Information Requests

Whale Tail Pit Expansion Project Proposal

February 21, 2019

Figure 11 from Appendix 6-H of the FEIS for the Expansion Project

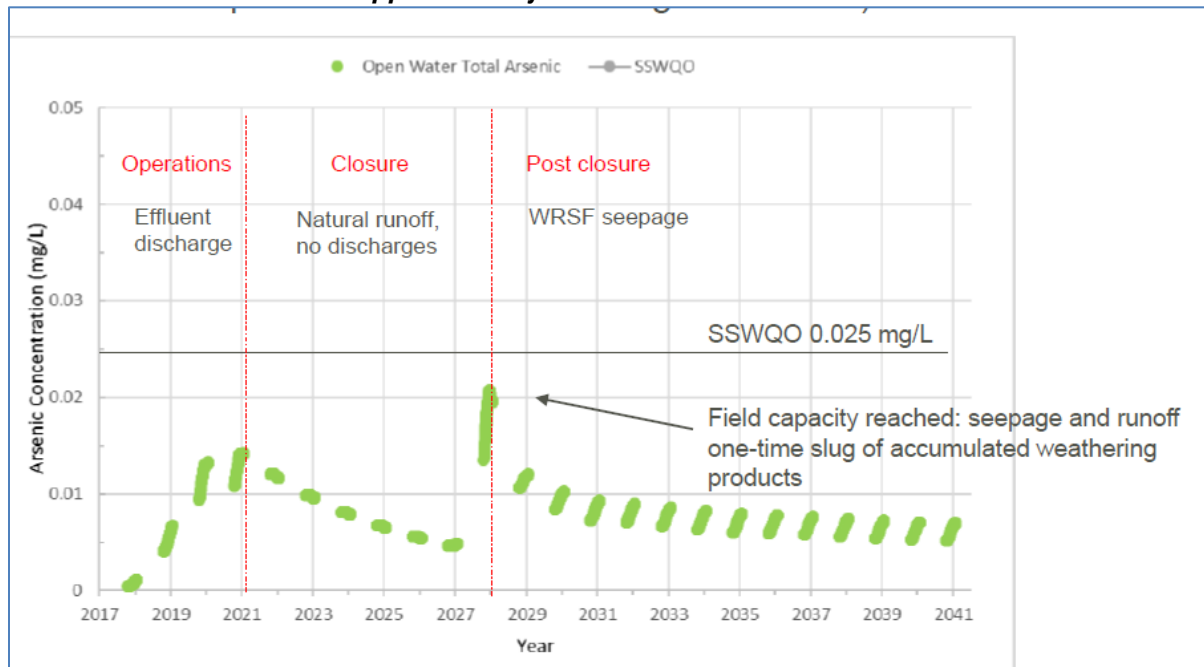
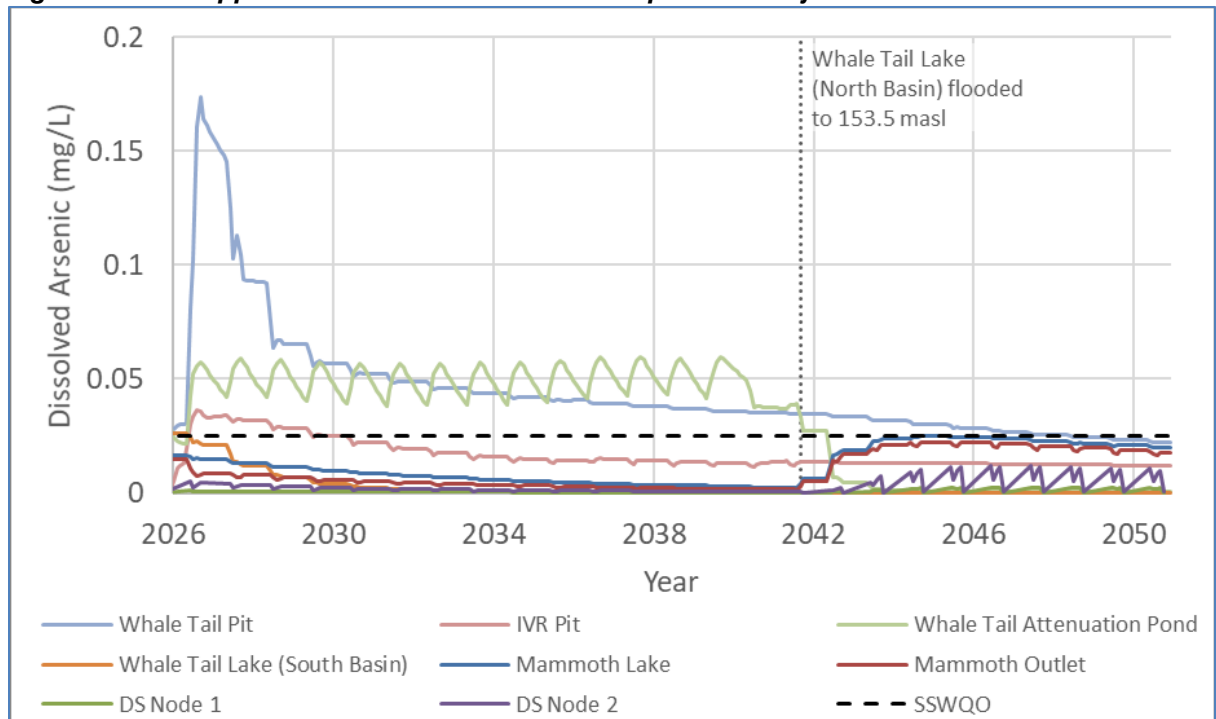
Information Request Number	CIRNAC IR#: 1
To	Proponent – Agnico Eagle
Subject	Comparative Analysis of Environmental Modelling Results for the Approved and Expansion Projects
Reference(s)	FEIS and supporting documentation
Issue/Concern	<p>The FEIS and supporting documentation presents descriptions of the scope of the Expansion Project relative to the scope of the Approved Project. This includes new infrastructure and operational requirements associated with the expansion of the mining operation. Chapters 4 to 7 of the FEIS also contrast and compare the predicted environmental impacts associated with the Approved Project and proposed expansion. However, the FEIS does not provide a comparative analysis of the environmental modelling results generated in support of the two projects.</p> <p>To illustrate, on July 26th, 2018 AEM provided CIRNAC with a figure summarizing predicted arsenic concentrations in Mammoth Lake from the Approved Project. That figure (reproduced below) indicates that post-closure arsenic concentrations in Mammoth Lake are predicted to be approximately 0.007 mg/L (i.e., roughly 25% of the Site-Specific Water Quality Objective (SSWQO)). In contrast, Figure 11 from Appendix 6-H of the FEIS for the Expansion Project (also reproduced below) indicates that arsenic concentrations in Mammoth Lake during the closure phase will be roughly equivalent to 100 % of the SSWQO. Despite the significant increase in predicted arsenic concentrations between the Approved Project and the Expansion Project (i.e., an increase from 25% to 100% of the SSWQO), AEM has not presented: a) a comparison of the results; or b) an explanation for the substantive differences between the water quality predictions for the two projects. As a result, CIRNAC is unable to determine the significance of the incremental impacts associated with the new undertaking.</p> <p>While the example provided above focuses on the Freshwater Environment, the FEIS for the Expansion Project also lacks comparisons for Atmospheric and Terrestrial environmental components.</p>

Information Request	<p>CIRNAC recommends that the FEIS be revised to include comparative analyses of environmental modelling and predictions conducted on the Approved Project and the Expansion Project. The analyses should be quantitative and, where substantive changes in the environmental modelling results have occurred between the two projects, the rationale for the changes should be provided. The additional information is necessary to evaluate the incremental environmental impacts associated with the Expansion Project.</p>

Note: The following two figures are provided to support the discussion presented in CIRNAC Information Request #1.

Figure 6-I-2 from Appendix 6-I of the FEIS for the Expansion Project

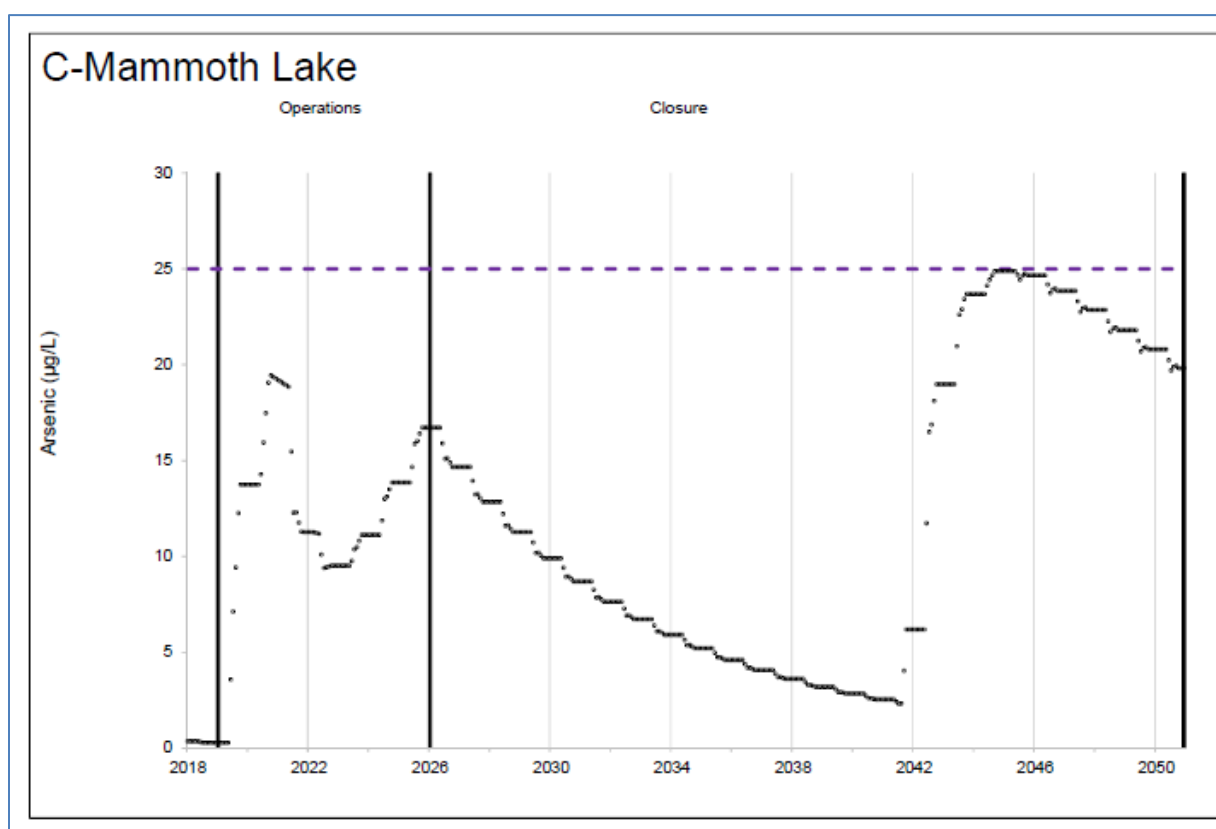
Information Request Number	CIRNAC IR#: 2
To	Proponent – Agnico Eagle
Subject	Effluent Mixing Zone Delineation and Impact Characterization
Reference(s)	FEIS Vol. 6, Freshwater Environment APPENDIX 6-H Addendum Mine Site and Downstream Receiving Water Quality Predictions APPENDIX 6-I Addendum Water Quality Prediction Summary
Issue/Concern	<p>The water quality predictions presented by AEM indicate that some parameters will approach their respective environmental quality criteria (EQC) in the receiving environment. For example, Figure 6-I-2 from Appendix 6-I (reproduced below) indicates that arsenic concentrations in Mammoth Lake will be roughly equivalent to the Site-Specific Water Quality Objective (SSWQO) during the closure phase. The following statement from Appendix 6-H is relevant when interpreting the results presented in the figure (emphasis added):</p> <p><i>Results presented for the receiving environment and downstream lakes assume fully mixed conditions where the effluent and downstream lake overflows are conservatively assumed to be mixed instantaneously. In reality, constituent transport and mixing will occur spatially and over time.</i></p> <p>We do not agree with AEM's statement that this is a conservative approach. To the contrary, the assumption that discharges to surface water receivers will be instantaneously and fully mixed will result in an under-prediction of potential adverse environmental consequences. While the modelled results predict the <u>average</u> contaminant concentrations within the surface water receivers, they fail to account for the spatial variability that will inevitably occur under field conditions.</p> <p>Based on the average water quality predictions noted above, we would expect that arsenic concentrations at some locations in Mammoth Lake will be elevated above the SSWQO (e.g., in the vicinity of the discharge point from Whale Tail Lake). AEM's submission does not provide clarity on the spatial extent of these elevated arsenic concentrations. Specifically, the FEIS for the Expansion Project does not include any mixing studies to demonstrate that discharges to surface water receivers will remain below applicable EQC at all locations. Furthermore, an assessment of potential ecological impacts associated with the exceedances has not been provided.</p> <p>While AEM has indicated that the water quality criteria for the Approved Project would also be applied to the Expansion Project, there is a lack of clarity regarding where those criteria would be applied. For example, it is not clear whether SSWQO would be achieved at all locations within receivers or only on average. Ambiguity regarding the size of the post-closure mixing zone contributes to this uncertainty.</p> <p>The deficiencies noted above make it difficult to assess the physical extent, nature and significance of potential adverse impacts in areas that have water quality concentrations above the proposed criteria.</p>

Information Request	<p>CIRNAC recommends that AEM clearly indicate the spatial extent within all surface water receivers in which concentrations of potential contaminants may exceed the SSWQO or other applicable criteria. The evaluation should identify and characterize potential ecological impacts in areas where the proposed water quality criteria may be exceeded.</p> <p>Using the findings of the assessment noted above, CIRNAC recommends that AEM clearly indicate the monitoring and compliance points that will be used to assess performance against the SSWQO.</p>
----------------------------	---

Note: The following figure is provided to support the discussion presented in CIRNAC Information Request #2.

Figure 11 from Appendix 6-H of the FEIS for the Expansion Project

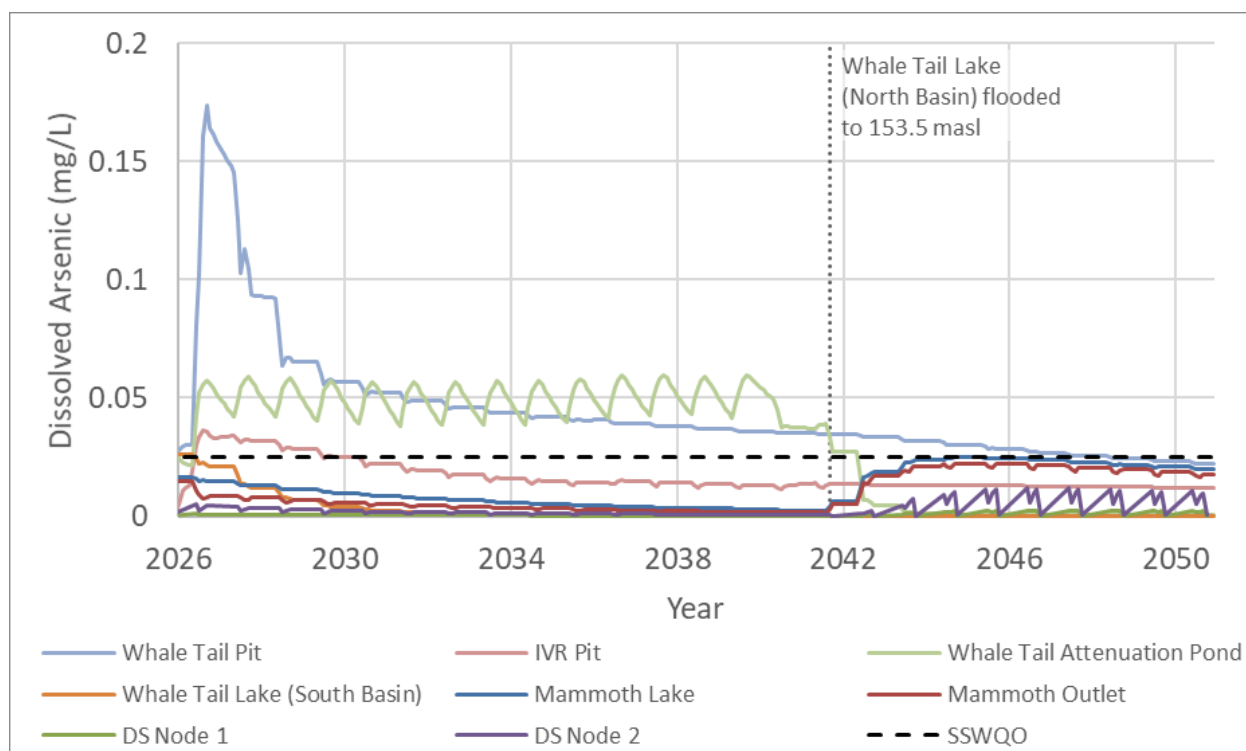
Information Request Number	CIRNAC IR#: 3
To	Proponent – Agnico Eagle
Subject	Water Quality Prediction Margin of Error Relative to Environmental Quality Criteria
Reference(s)	FEIS Vol. 6, Freshwater Environment APPENDIX 6-H Addendum Mine Site and Downstream Receiving Water Quality Predictions APPENDIX 6-I Addendum Water Quality Prediction Summary
Issue/Concern	<p>Figure 11 from Appendix 6-H (reproduced below) summarizes the predicted dissolved arsenic concentrations in surface water receivers. Based on the results presented in the figure, we note the following:</p> <ol style="list-style-type: none"> 1. Arsenic concentrations in Whale Tail Lake south are predicted to exceed the SSWQO during the operational phase, despite the fact that the water body will continue to serve as fish habitat. AEM has not provided a description of anticipated ecological impacts associated with the exceedance. 2. Arsenic concentrations in the Whale Tail Pit are predicted to remain above the SSWQO until 2051. Based on the slow rate at which arsenic concentrations decline prior to that date, we assume that there is a high degree of uncertainty regarding when compliance will be achieved. For example, higher than anticipated arsenic loadings could delay the compliance date by multiple years. 3. Average arsenic concentrations in Mammoth Lake are predicted to remain slightly below the SSWQO for an extended period.¹ <p>Each of these points demonstrates there is limited “margin of error” between the modelled arsenic concentrations and levels at which impacts may occur (i.e., the SSWQO).</p> <p>To address the elevated results, AEM has indicated that a number of conservative assumptions were incorporated into the modelling. For example, AEM states that the modelling conservatively included seepage from the Whale Tail and IVR Waste Rock Storage Facilities (WRSF), despite the fact that similar seepage has not been observed at Meadowbank. As described further in IR #4, the Meadowbank WRSF may produce seepage in the future when field capacity is reached and, as such, CIRNAC does not consider the potential for seepage from the Whale Tail Project to be a conservative assumption. Further, there are instances where AEM's modelling has excluded potentially significant source terms. Most notably, the modelling is based on the optimistic assumption that WRSF covers will be constructed exclusively of “clean” material. This results in a reduction of the modelling conservatism.</p> <p>When evaluating the limited margin of error in the water quality modelling results noted above, it should be emphasized that actual results can vary significantly from predictions. The following statement in Appendix 6-H indicates AEM is fully aware of</p>

¹ For reference, Appendix 6-H states: “Mammoth Lake and downstream water qualities are fully recovered by post-closure, with no long-term effects to water quality.” As indicated in Figure 11 above, this is not accurate; Mammoth Lake does not return to baseline and therefore will not be “fully recovered”.

<p>this limitation (emphasis added):</p> <p><i>Given the uncertainties associated with the modelling and an average climate year in the water balance, <u>the predicted concentrations are considered to be order-of-magnitude estimates.</u></i></p> <p>In summary, based on the information presented to date and the inherent uncertainty associated with environmental modelling, there is insufficient margin of error between the water quality predictions and relevant impact thresholds (e.g., SSWQO). While AEM has stressed that this is attributable to the conservatism of their analyses, CIRNAC is of the opinion that further evidence is required to justify this conclusion.</p>
Information Request	<p>CIRNAC recommends that AEM perform quantitative sensitivity analyses of their water quality modelling. The analyses should systematically quantify potential variability in all major source terms and associated pathways (e.g., elevated arsenic seepage from pit walls, WRSF and mine areas). CIRNAC acknowledges that some sensitivity analyses have already been performed (e.g., variable hydraulic conductivities) but a more comprehensive analysis of all variables is justified. The additional information is necessary to verify the proponent's conclusion that their modelling results are highly conservative and that they likely over-predict any potential impacts.</p>

Note: The following figure is provided to support the discussion presented in CIRNAC Information Request #3.

Figure 5 from Appendix 6-H of the FEIS for the Expansion Project

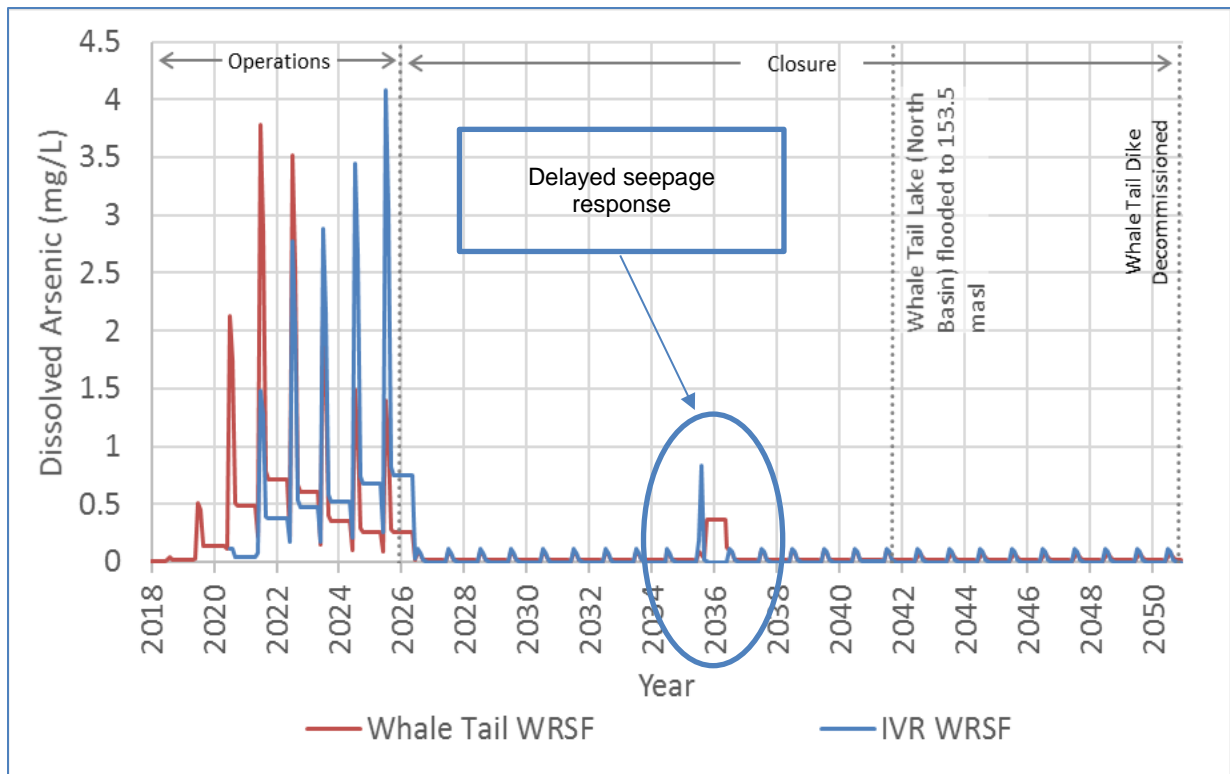
Information Request Number	CIRNAC IR#: 4
To	Proponent – Agnico Eagle
Subject	Contamination of Waste Rock Covers and Other Mine Infrastructure by Waste Rock with Elevated ARD/ML Potential
Reference(s)	APPENDIX 8-A.1: Whale Tail Pit –Waste Rock Management Plan APPENDIX 6-H Addendum Mine Site and Downstream Receiving Water Quality Predictions
Issue/Concern	<p>Similar to the Approved Project, the majority of waste rock associated with the Expansion Project will be deposited in Waste Rock Storage Facilities (WRSFs) that are predicted to remain frozen year-round. As a result, the permanently frozen rock is anticipated to be a negligible source of arsenic seepage during the post-closure phase. However, the active zone of the WRSFs will be an ongoing source of arsenic seepage and loadings to the downstream receiving environment. The extent to which this occurs will depend on the geochemical properties of the material used to construct the WRSF covers. AEM states that the WRSF covers will be constructed exclusively of “clean” waste rock (i.e., rock with low ARD/ML potential). They note that this position is supported by: a) the company’s rigorous waste rock management practices; and b) observations from the Meadowbank Mine. The following summaries present an overview of CIRNAC’s position and concern on these topics.</p> <p><u>Waste Rock Management Practices</u></p> <p>While CIRNAC agrees that AEM’s waste rock management approaches are generally consistent with standard industry practices and that they should be effective in <u>reducing</u> the extent and probability of cover contamination, the department does not support the conclusion that such contamination can be fully eliminated. Within the context of an operating mine, many factors are likely to result in some degree of cover contamination, including but not limited to: ineffective geochemical characterization; physical mixing of waste types during extraction, transport, storage and cover construction; and human error (e.g., placing waste rock in the wrong dump). All of these factors are known to have occurred at other mines, some of which possessed robust waste rock management practices. Within this context, it is overly-optimistic to assume that the WRSF covers will be constructed exclusively of clean waste rock.</p> <p>CIRNAC identified similar concerns during the environment assessment and regulatory processes for the Approved Project. In response to those concerns, AEM conducted additional modelling of WRSF seepage with varying levels of cover contamination. The additional modelling clearly demonstrated that low levels of cover contamination are likely to result in WRSF seepage that has highly elevated arsenic concentrations. CIRNAC considers this to be an important finding that warrants serious consideration. However, AEM has not incorporated the potential impacts of cover contamination into their modelling of the Expansion Project. Further, based on the documentation reviewed to date, it appears AEM has not evaluated the potential impacts associated with similar contamination of construction materials for mine infrastructure such as roads and lay down areas.</p> <p>When considering the implications of such contamination, CIRNAC draws attention to the fact that the Expansion Project has limited “margin of error” before arsenic concentrations will exceed applicable criteria (as described in IR #3). As a</p>

<p>consequence, there is a potential that very low levels of contamination would result in unacceptable impacts. In addition, the Expansion Project involves waste rock lithologies that have elevated ARD/ML potential relative to the Approved Project.² Therefore any cover contamination that does occur, may have a greater negative impact on water quality than for the Approved Project. Collectively, these considerations heighten the need to assess the potential impacts of contamination of covers and other mine infrastructure by waste rock with elevated ARD/ML potential.</p> <p><u>WRSF Seepage from the Meadowbank Mine</u></p> <p>In their evaluation of potential risks associated with the Whale Tail WRSFs, AEM stated that the modelling likely over-predicts the impact of WRSF seepage on surface water quality. A key line of evidence in this conclusion is that the Meadowbank WRSF is not generating seepage. For example, Appendix 6-H states: <i>“Site data from Meadowbank shows that there is very little to no runoff or seepage from the waste rock piles, and it is likely to be the case at the Extension Project as well.”</i></p> <p>CIRNAC does not support AEM's conclusion because it fails to consider the delayed seepage response attributable to the field capacity of the WRSFs. To illustrate, Figure 5 from Appendix 6-H (reproduced below) indicates that the Whale Tail and IVR WRSFs only generate a spike of arsenic concentrations when the field capacity of the piles is reached approximately 10 years after closure (i.e., in 2036). Prior to that date, the piles will continue to absorb moisture and are expected to generate negligible seepage. CIRNAC expects that the Meadowbank WRSF is experiencing a similar delay and, as such, there is a potential that seepage rates and loadings will increase significantly once the field capacity has been reached. The department therefore cautions against using the current performance of the Meadowbank WRSF as an indication of long-term seepage from the Whale Tail waste rock deposits.</p>

Information Request	<p>CIRNAC recommends that the following additional information be provided prior to the Technical Review phase. The information is necessary to determine potential long-term environmental impacts associated with the proposed project.</p> <p>4a) AEM should conduct a sensitivity analysis to assess the water quality impacts associated with 1% contamination of WRSF covers with ARD/ML material (e.g., komatiite and iron formations). The sensitivity analysis should also evaluate the impacts associated with similar contamination of other mine infrastructure such as mine roads, lay down areas, etc.</p> <p>4b) If AEM uses the Meadowbank WRSF seepage results as evidence for the current application, AEM should specify the date at which the facility is predicted to reach its field capacity.</p>

Note: The following figure is provided to support the discussion presented in CIRNAC Information Request #4.
